DETAILED ASSESSMENT REPORT DEVELOPMENT SERVICES

REQUEST TO AMEND MASTER PLAN APPROVALS

APPLICATION DETAILS	
Application No:	MPC18/0004.01 & MPC11/0003.07
Applicant:	Stockland Kawana Waters Pty Limited
Proposal:	<ul style="list-style-type: none"> • Approval of amended Plan No. 44 (Detailed Planning Area Plan - Detailed Planning Area 2) 2015 • Approval of amended Master Plan No. 104 (Site Development Plan - Detailed Planning Area 2 - Precinct 8) - 63 Multiple Dwellings and 816m² ground floor retail.
Received Date:	31/05/2019
Request for Further Particulars Date:	24/06/2019
Duly Made Date:	02/09/2019
Decision Due Date:	12/10/2019 (40 calendar days, DCP-1)
Number of Submissions:	N/A
PROPERTY DETAILS	
Division:	3
Property Address:	Wurley Drive BOKARINA QLD 4575
RP Description:	Lot 905 SP302188
Land Area:	3,977m ²
Existing Use of Land:	Vacant
STATUTORY DETAILS	
Planning Scheme:	Sunshine Coast Planning Scheme 2014
SEQRP Designation:	Urban Footprint
Strategic Framework Land Use Category	Urban
Local Plan Area:	Kawana Waters

PROPOSAL:Amended Site Development Plan

Figure 8. Amended Map 7 of Master Plan No. 44 (arrow indicated proposed left-in driveway)

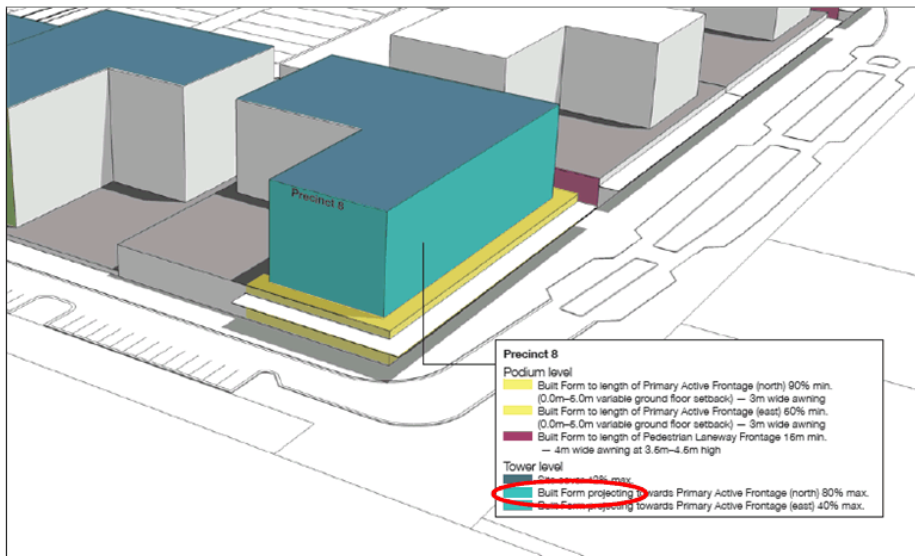
- Amendment to Map 7 to show an “in-only” driveway to the site from Longboard Parade.

- The in-only driveway will improve legibility for customers and visitors to the site arriving by car. Movements have been limited to in only to reduce conflicts with pedestrians as much as possible. The driveway is located outside the active frontage section of the boundary to Longboard Parade. Council's engineering specialists advice the driveway has sufficient sightline and separation from corners/intersections to operate safely.
- The proposed amendment to Map 7 of Master Plan No.44 reflects the location of the left-in only driveway included on the SDP architectural and engineering plans.
- Amendment to Maps 13A and 13B to increase the tower site cover applying to the subject site (Precinct 8) from 40% to 42%.

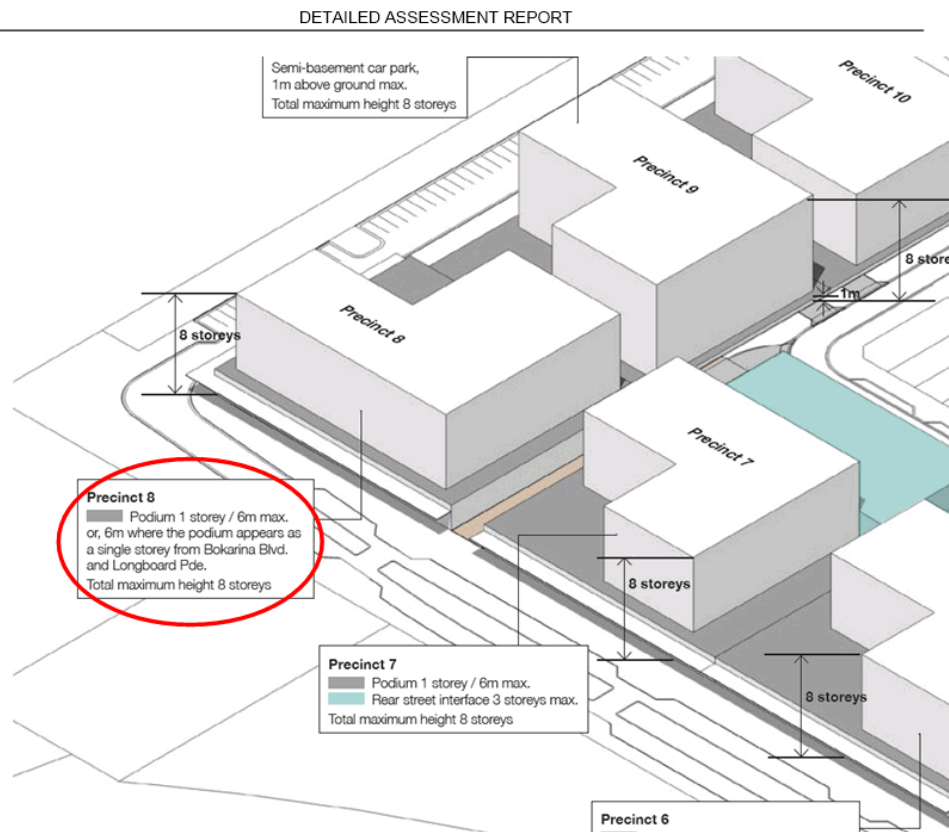
- This minor increase is considered acceptable as the building complies with all required setbacks and provides a high quality architectural outcome for the site (refer to built-form comments below)
- Amendment to Map 13C to enable a podium on the subject site (Precinct 8) to comprise more than one storey, where it appears as a single storey from the street frontages, and does not exceed the existing maximum height of 6m.

- This change is supported as it enables additional flexibility in the design of the podium component of development on the site whilst not affecting the visual appearance from the street frontages.
